Product Change Notification - SMART Payout

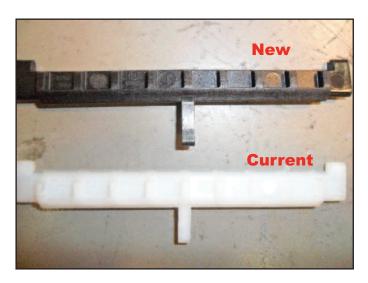
As part of our continuous quality improvements, with immediate effect, the SMART Payout has been modified as shown below. Both Cam Gears have been upgraded (PM870, PM871) as well as a change to the Diverter Actuator (PM869) shown here. These modifications improve stability when using a 24V power supply and do not affect existing 12V applications. To request the full Product Change Notification document email support@innovative-technology.co.uk and please feel free to consult your local support team for assistance and recommendations before implementing the SMART Payout in 24V applications.
